## County Offaly Development Plan 2021 - 2027

Draft Plan : Submission on behalf of Flanagan Properties Ltd, Cormac Street, Tullamore  
Objection to draft Plan in regard to its land at Riverview, Cloncollig, Tullamore

## Proposed Amendment – Delete the identified ‘Constrained land’ designation from this site

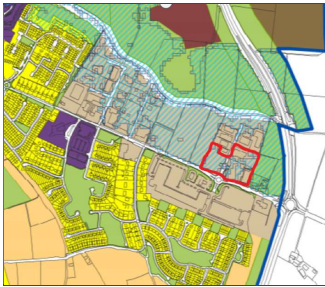
4. The site is identified as ‘constrained’ in the draft Plan, by virtue of the strategic flood risk assessment carried out by OCC and its partners. However, this takes no recognition of the fact that a detailed Flood Risk Assessment has been carried out for the land in relation to the planning permission for retail warehousing at the site (attached), and that OCC and ABP have recently accepted through the grant of planning permission (18/535) that retail development is acceptable at this site. It is clear, therefore, that the site is not at risk of flooding, and will not contribute to flooding elsewhere, if developed for retail warehousing purposes. There is no need, therefore for that constraint to be included for this site, which affects certainty and deliverability of land.

5. Flanagan Properties welcomes the opportunity to participate in this plan making process and requests that its comments are taken into consideration.
6. In particular, the following changes are requested :
  - Removal of the ‘constraint to development’ annotation – recognising that
    - A single landowner owns / controls this site, which landowner has private finance available to proceed with development of the site, when conditions are favourable;
    - There is no flooding issue relating to commercial development at the site, as demonstrated in the attached Flood Risk Assessment and as accepted by OCC and ABP in the granting of planning permission; and
    - There is no other technical constraint to development.
